William States Lee III Nuclear Station - Docket Nos. 52-018 and 52-019

AP1000 Combined License Application for the William States Lee III Nuclear Station Units 1 and 2 Response to Request for Additional Information

Ltr# WLG2010.07-06

Attachment 164-06

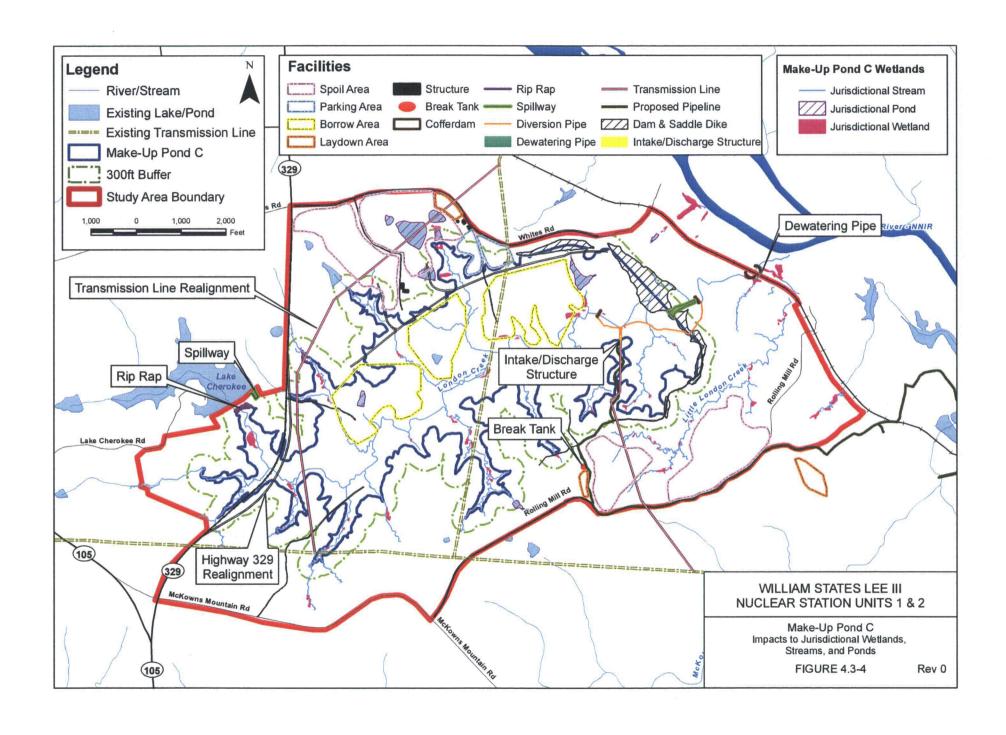
Provide a discussion regarding the impacts to wetlands that would occur outside the area to be inundated by Pond C (e.g., wetlands impacted by the replacement of the rail road culverts). Include in the discussion any related mitigation that would occur.

Attachment 164-06 Mark up of ER Supplement, Figure 4.3-4

A rerouted 44-kV transmission line crosses Make-Up Pond C (Figure 4.3-4). This 100-ft wide easement requires crossing several unnamed tributaries and impoundments. A new 44-kV transmission line extends from the Make-Up Pond C pump structure to the existing 44-kV transmission right-of-way within the Lee Nuclear Site (Figure 4.3-4). This 100-ft wide easement requires crossing three streams. Table 4.3-4 and Table 4.3-5 quantify the impact from both transmission lines. Due to the small size of the area and the ability to avoid environmentally sensitive sites, impacts associated with the transmission lines are considered SMALL.
